Flight Procedures Cover Page	Task Action: Amendment	Task Type: Segment	Estimated Chart Date: 01/27/2022	APWS Task ID: A3DFB2D8C12647A39D2E92CE8CE60A2B	APWS Project ID: 5BC27F8393144BA89EF0C231C7573D4C
Procedure: V88 TUL VTAC, OK TO SGF VTAC, MO		Enroute: YES	Specialist: Martinelli, Tara		Agreement Number:
Airport ID:			Airport City:		State:
Facility ID:	Facility Type:	Flight Inspection Remark Type:			
<p>Procedure Comments: AIRWAY STARTING POINT: TULSA (TUL) VORTAC 361146.51N/0954717.31</p> <p>PROCESSED IAW TECHNICAL SUPPORT GROUP (AJF-17) MEMO DATED 07/07/2021, SUBJECT: GUIDANCE FOR PROCEDURAL CHANGES REQUIRING FLIGHT INSPECTION/VALIDATION.</p> <p>CONTACT DON LANIER: AJV-A431 405-954-8242</p>

V88 TUL VORTAC TO SGF VORTAC

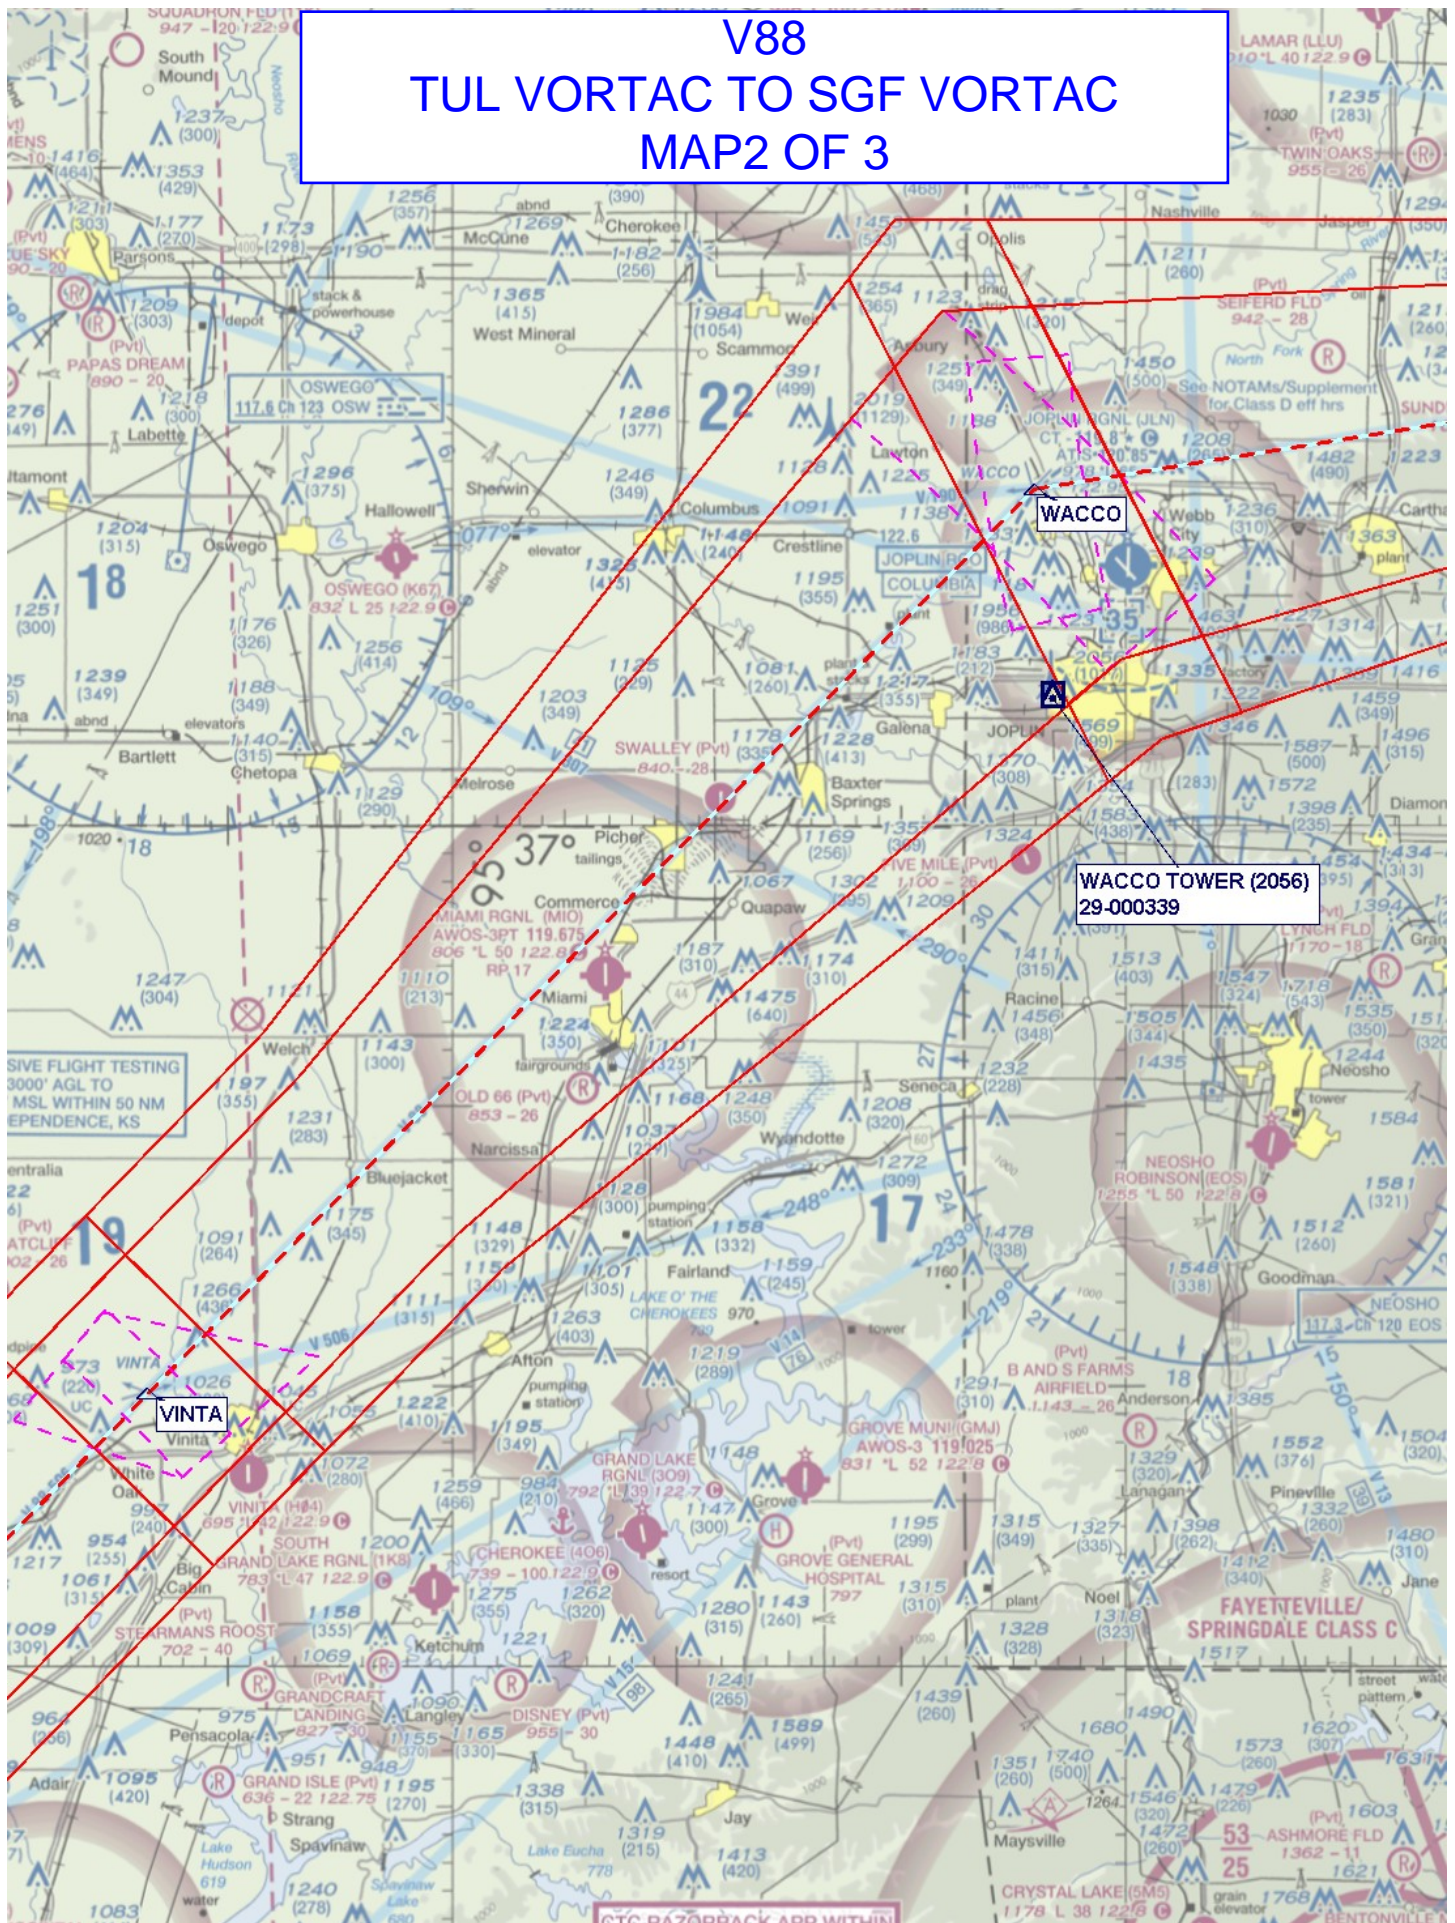
REMOVED MEA BREAK AT NARCI

VINTA TO WACCO
MRA/MEA 6200
MOCA 3100
GNSS MEA 4000

ADDED MCA AT VINTA
6200 NE

WACCO TO SGF
MEA/MRA 6200
MOCA 3100
GNSS MEA 4000

REMOVED ALL MCA RESTRICTIONS AT
WACCO
REMOVED MEA BREAK AT WACCO
